Alpha-Omega Services, Inc.

Ref: Docket No. 71-9316

In response to your letters dated July 31, 2009; "Application for Certification of Compliance No. 9316 for the Models No. AOS-025, AOS-050, AOS-100 and AOS-165 Packages, Docket No. 71-9316- Request For Supplemental Information" and August 6, 2009; "Application for the Model No. AOS-165 – Not Accepted For Review", please find attached the supplemental information for Models AOS-025, AOS-050 and AOS-100.

Responses to the Request for Supplemental Information, July 31, 2009

Figure 3-2. Carbon Steel Conductivity versus Temperature Used in Model AOS-100B

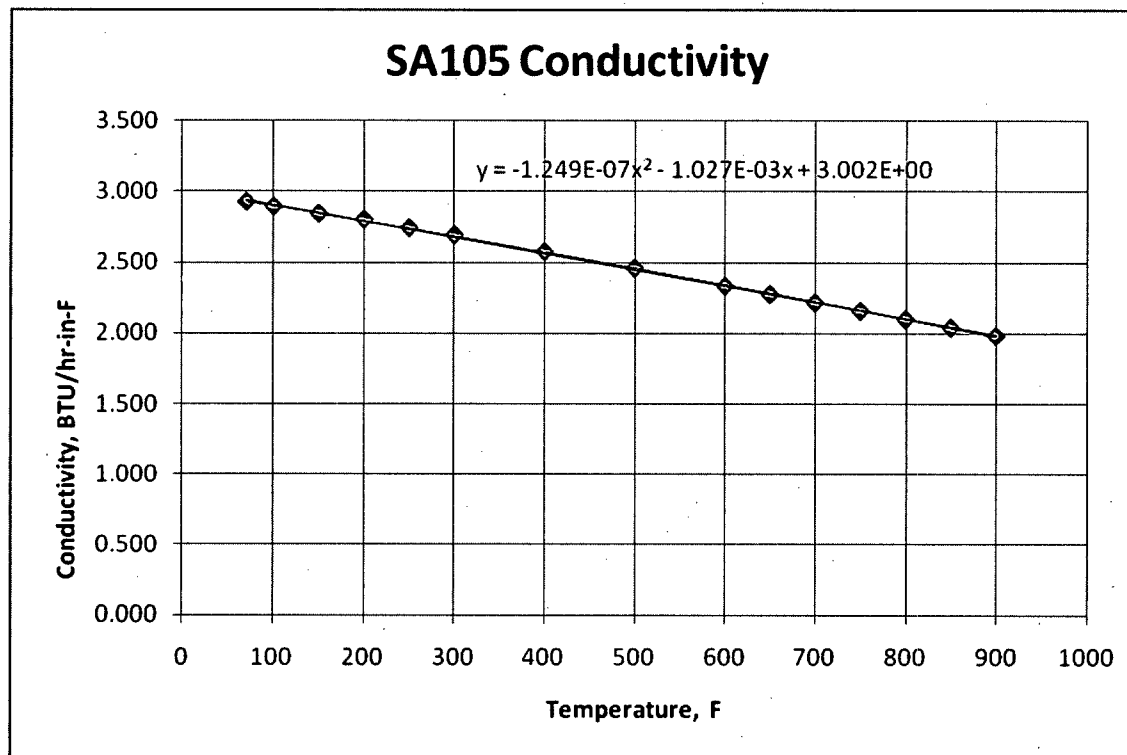
It was noticed that there is no description of the boundary conditions during the 30-minute fire condition. Paragraph 3.3.1.3.x will be added, as provided below.

Table 3-7 lists the thermophysical properties of carbon steel SA105, as they apply to the transport packages (3-13) AOS-100B. Figure 3-2 illustrates the relationship between conductivity and temperature for the carbon steel material.

Figure 1. Case 1 Temperatures

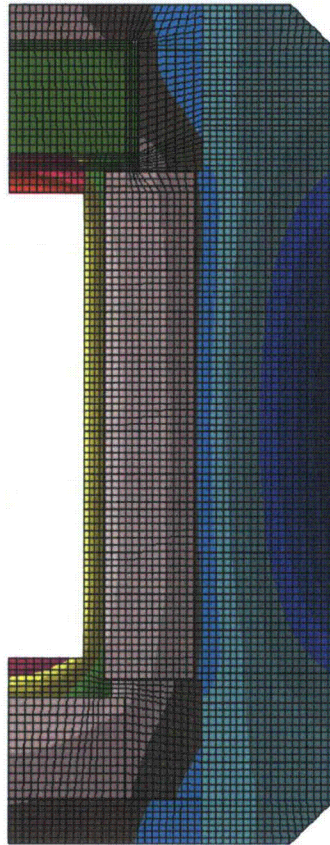
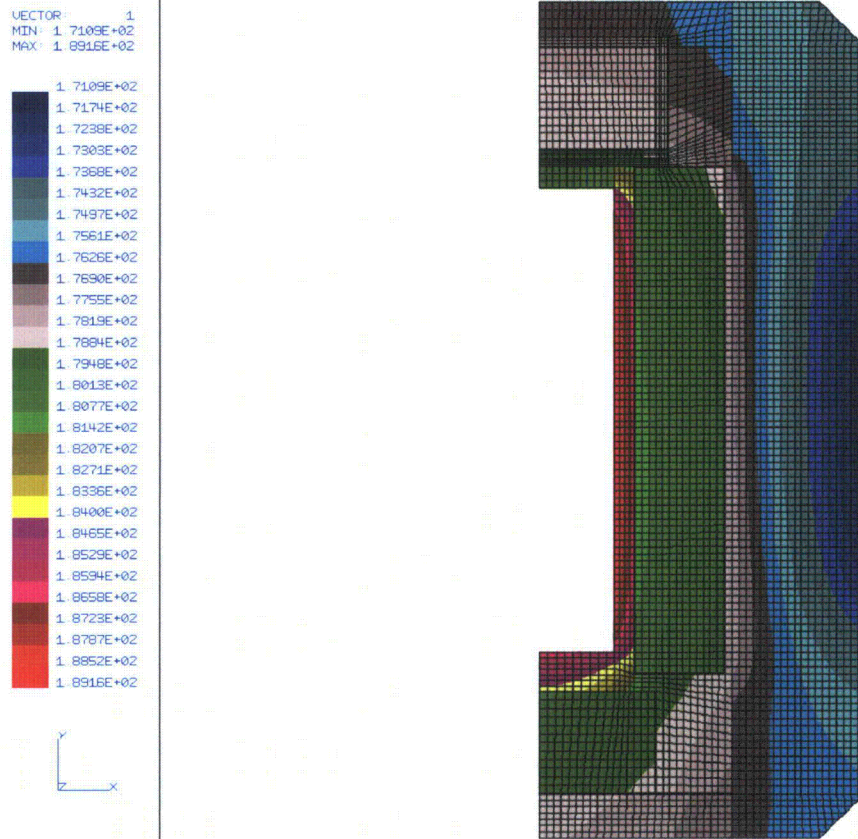
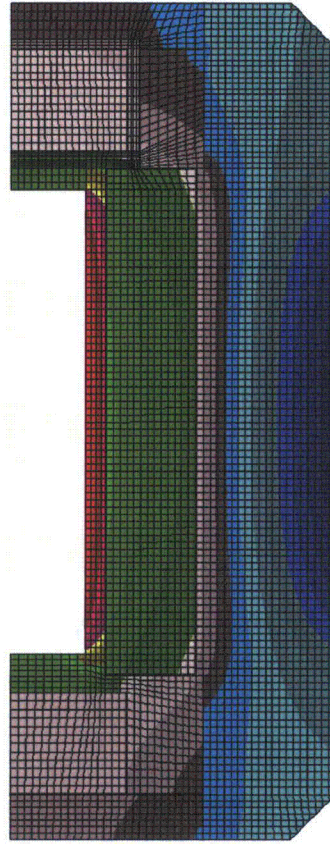
RSI 3-6: *Provide descriptions, including drawings, of the internal basket assemblies used in the various designs in Section 3.3.1 of the application. Describe the thermal interactions of the payload with the internal surfaces of the inner canister. Demonstrate that the decay heat generated by the contents is appropriately modeled in relation to the interior of the package*

A comparison of Tables 1 through 3 shows little variation in maximum temperature for the three heat distributions. Figures 1 through 3 show that Case 1, uniformly distributed decay heat, provides maximum temperature in the seal region. From Tables 1 through 3, the maximum temperature difference is less than 6°F.

DETAIL A

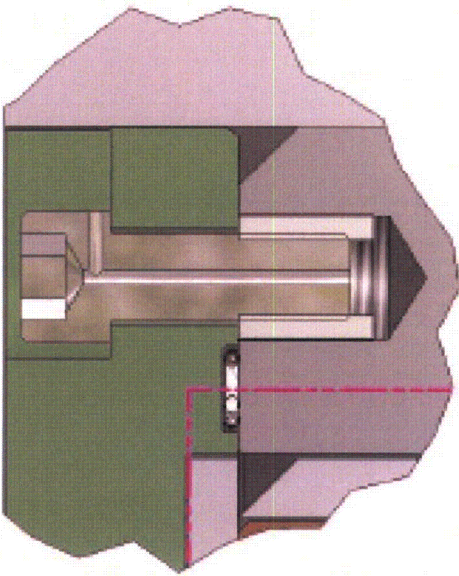
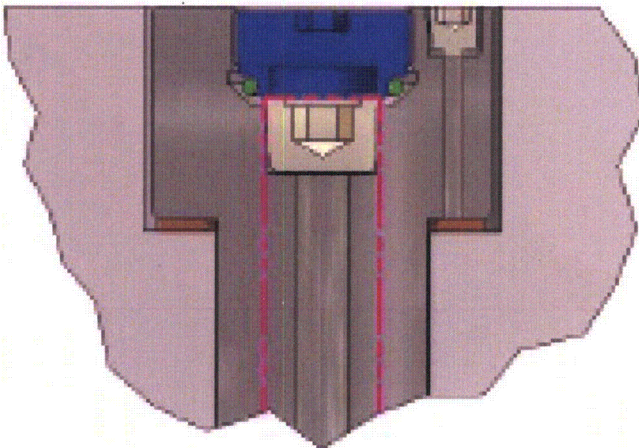
This information is needed to determine compliance with 10 CFR 71.51.

Figure 4-1 will be revised to clearly show that the lid seal inner "C" cross-section of the double seal is the primary seal and the outside seal is the secondary Seal. In the case of port seals, the threaded pipe is the primary seal and the elastomeric O-Ring is the secondary seal.

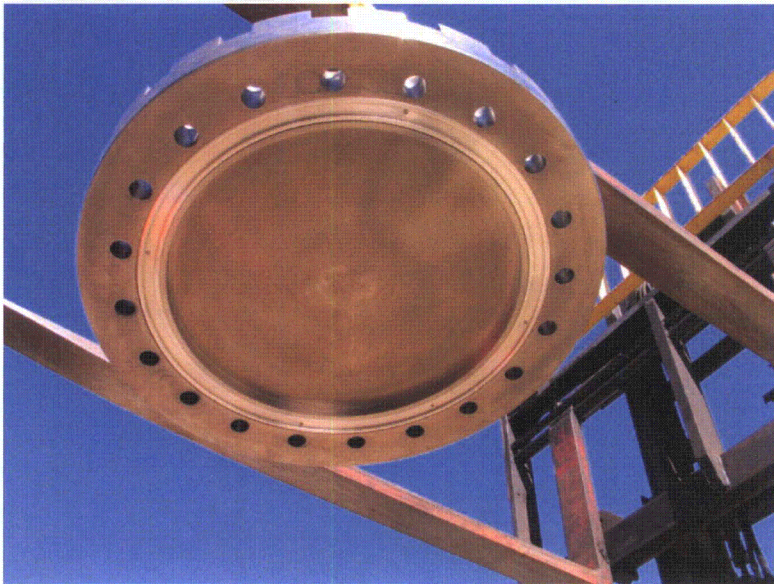
RSI 4-4: *Provide an additional explanation of the placement of the seals using four small screws, as mentioned on page 4-9 of the application.*

The attached photo illustrates how the seal is attached to the lid by the four screws. Located between the two "C" cross-sections of the seal, the screws are sized and installed in such a way as to prevent the screws from interfering with the deformation of the "C" cross-sections when the lid bolts are being tightened.
